UNITED STATES PATENT AND TRADEMARK OFFICE

10/728,549

Office Action Summary	Application No.		Applicant(s)	
	10/728,549		HAMMER, JAMES	
	Examiner		Art Unit	
	Tamara L. Graysay		3636

DETAILED ACTION

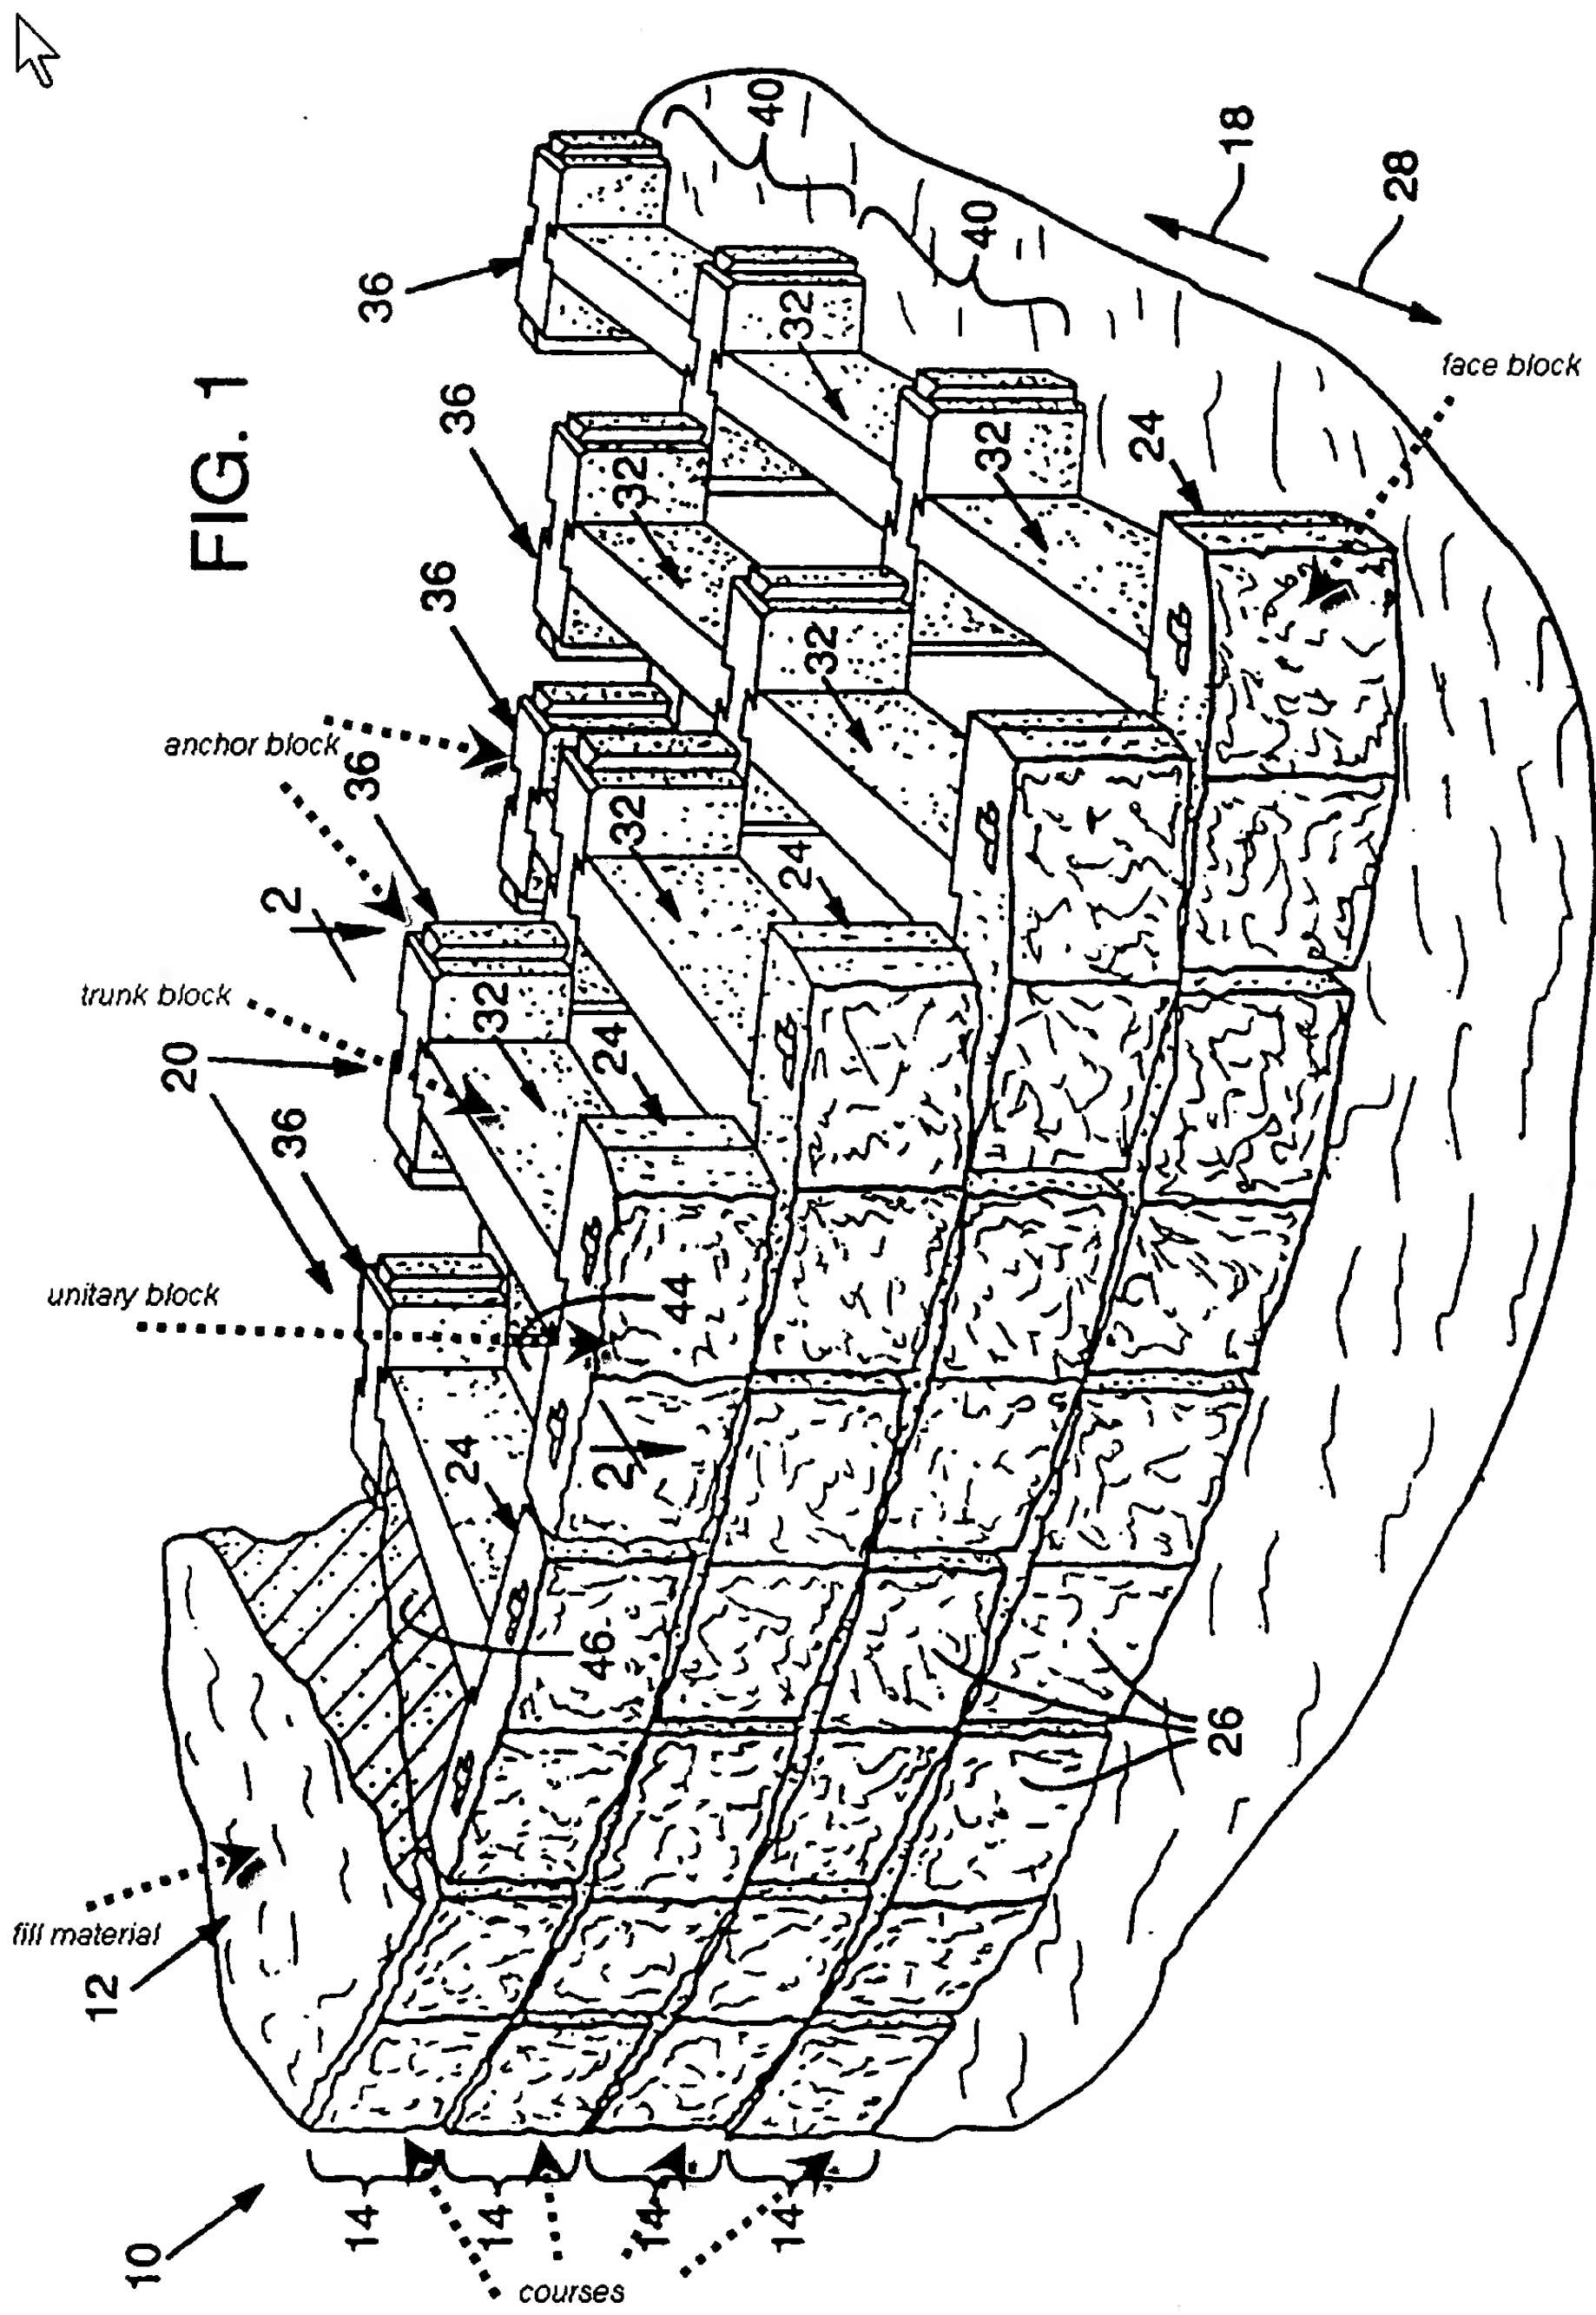
Claims 1-3: Hammer discloses a retaining wall (FIG. 1) comprising a first set of one or more courses (14), at least a portion of each comprising a plurality of unitary blocks placed side by side with respect to each other (24); and a second set of one or more courses, at least a portion of each comprising a plurality of block assemblies placed side by side (224, 32, 36), each block assembly comprising at least two interconnected block components; where the first set of one or more is located above or below the second set of one or more courses because all of the courses overlay one another. Also, reference is made to column 5, lines 51-54 which mentions that the face blocks can be used alone, i.e., not connected to other blocks in the direction of the block depth.

Claim 7: Hammer discloses (at the right end of FIG. 1) each block assembly comprises a first anchor block connected to the first trunk block opposite the face block; a second trunk block connected to and extending rearwardly from the first anchor block; and a second anchor block connected to the second trunk block opposite the first anchor block (40).

Claim 15: Hammer discloses chambers between adjacent block assemblies that are adapted to contain fill material (FIG. 1).

Claim 34: The block assembly course forming step includes forming a plurality of courses as depicted in FIG. 1.
